**Design Review & Historic Preservation Board
Agenda
July 23, 2020**

Draft
Design Review and Historic Preservation Board
Minutes
July 9, 2020

DRAWING NO. - A-2

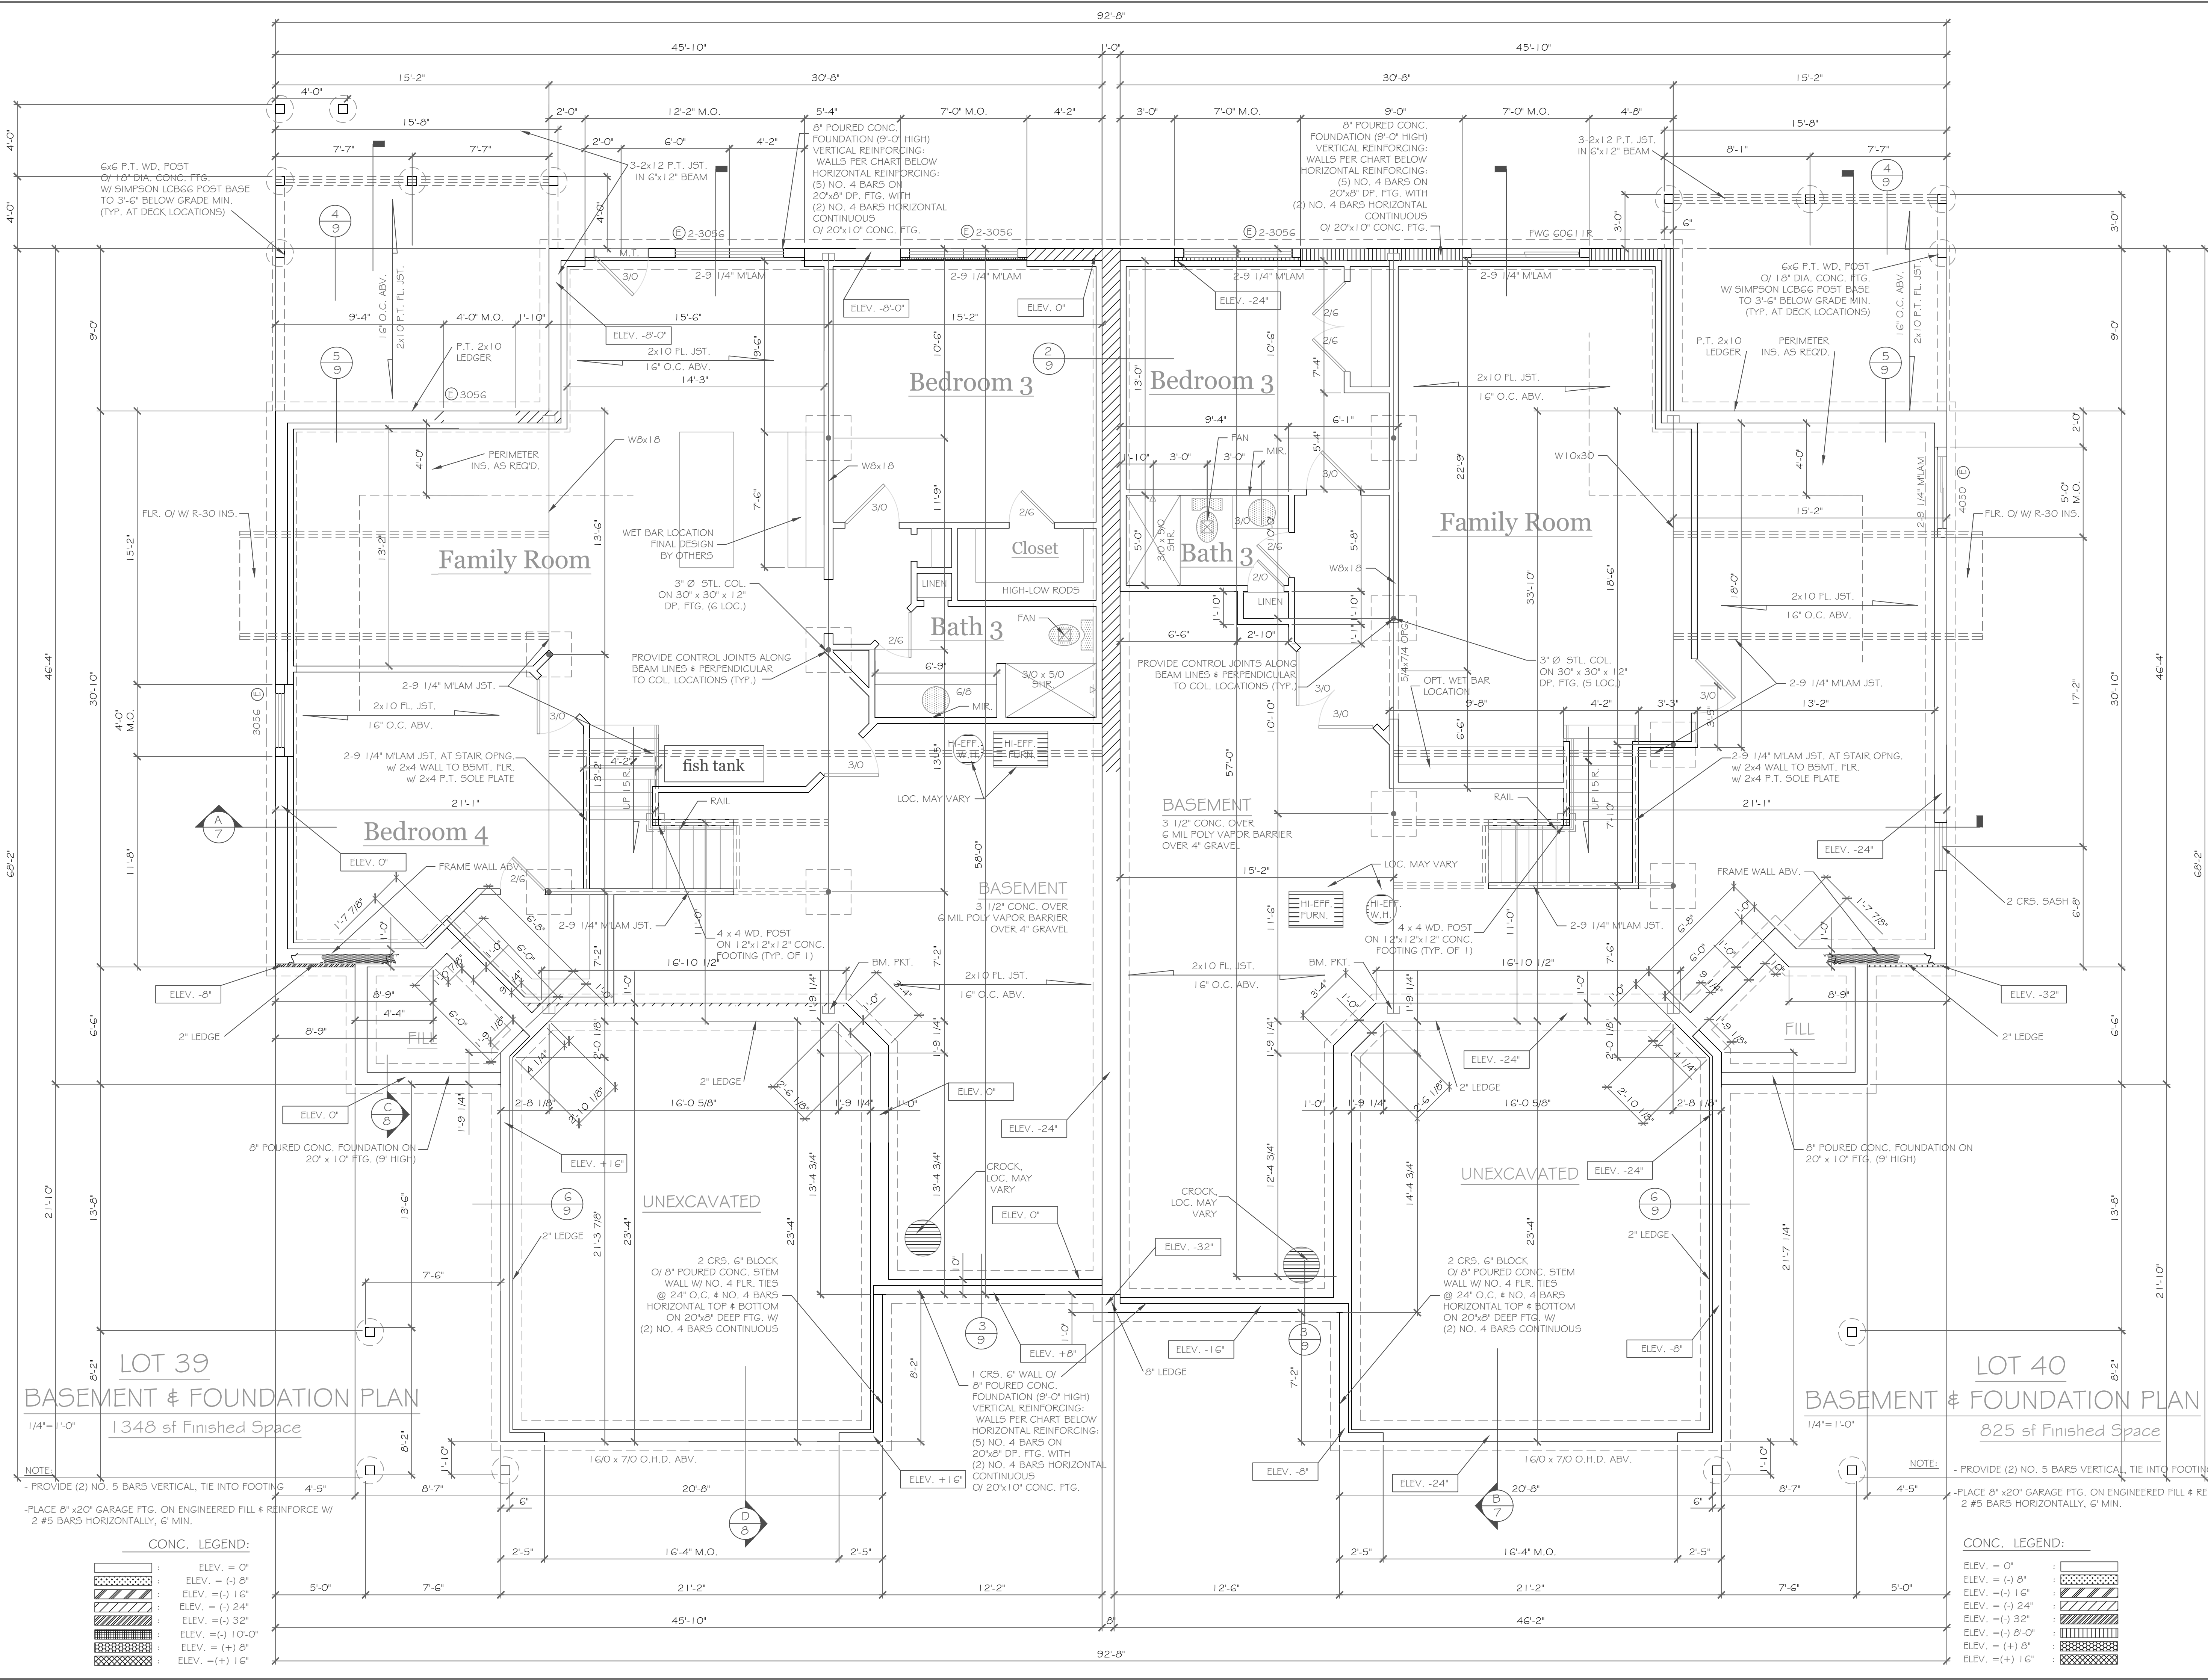
The Board further asked for further clarification of exactly what they being asked to approve by the Applicant. It was determined that the building with the red X with submitted blueprint drawing A-1 and A-2 and the two toned colors Booth Bay Blue and Light Mist are the colors submitted.

Finally, it was noted that corbels should be added under the right and left side fireboxes.

1. Corbels or brackets to be added under the right and left side fireboxes.
2. The colors of the units are two toned: Booth Bay Blue and Light Mist.
